# Process Sheet

Customer	: CU-DAR001 Dart Helicopters Services	Drawing Name	: HELI UTILITY BASKET LH/RH 350/355
Job Number	: 28292		
Estimate Number	: 10208		
P.O. Number	: N/A	Part Number	: D350607043
This Issue	: 8/22/2006	S.O. No.	: N/A
Prsht Rev.	: NC	Drawing Number	: D350-607 REV F P7-9
First Issue	: N/A	Project Number	: N/A
Previous Run	: 28291	Drawing Revision	: F
		Material	: N/A
Written By	:	Due Date	: 8/29/2006
Checked & Approved By	:	Qty:	1 Um: Each
Comment	: Est Rev:E as Per DSI9318 06-01-24 JLM

# DART SERVICE INSTRUCTION

TO AMEND INSTALLATION INSTRUCTIONS D350-607 REV. F

**Figure 5- Basket Replacement Parts**  
(D350-607-043 Heli-Utility-Basket™)

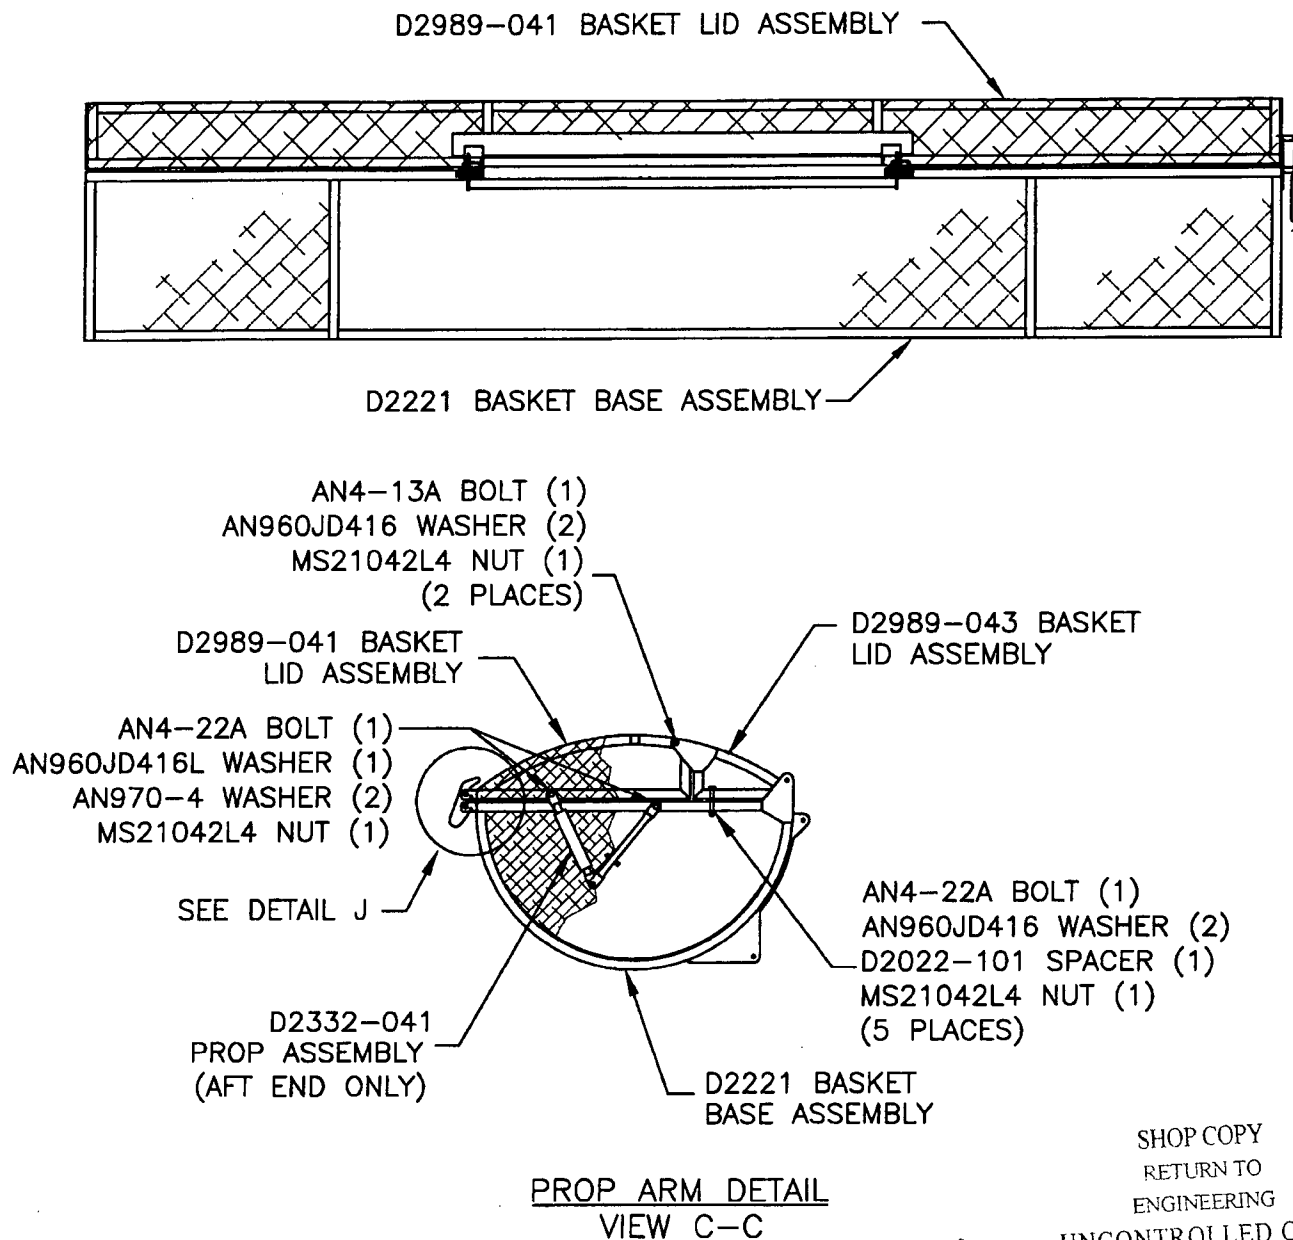
The corrected bolt stackup from Figure 5 of installation instructions D350-607 Rev. F is given below:

AN4-13A BOLT (1)  
AN960JD416 WASHER (1)  
HINGE PLATE (REF)  
**NAS1515H4 WASHER (1)**  
BASKET FRAME (REF)  
AN960JD416 WASHER (1)  
MS21042L4 NUT (1)  
(2 PLACES)

DESIGN CP	DRAWN BY CP	DART AEROSPACE LTD HAWKESBURY, ONTARIO, CANADA	
CHECKED H	APPROVED H	DRAWING NO. DSI 9318	REV. A SHEET 1 OF 1
DATE 06.01.06		TITLE WASHER ADDITION	SCALE NTS
A	06.01.06	NEW ISSUE

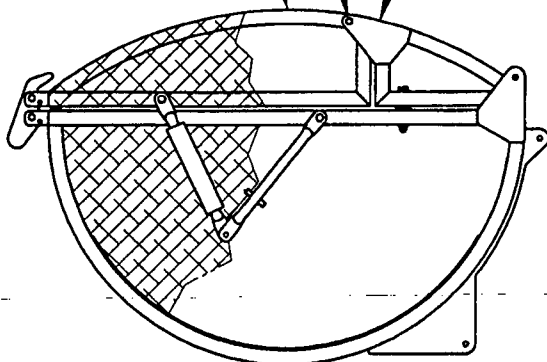
To reduce the possibility of damaging the finish, a **NAS1515H4** washer (2 places) has been added between the hinge plate and basket frame on the **D350-607-043/-047 Heli-Utility-Basket**.
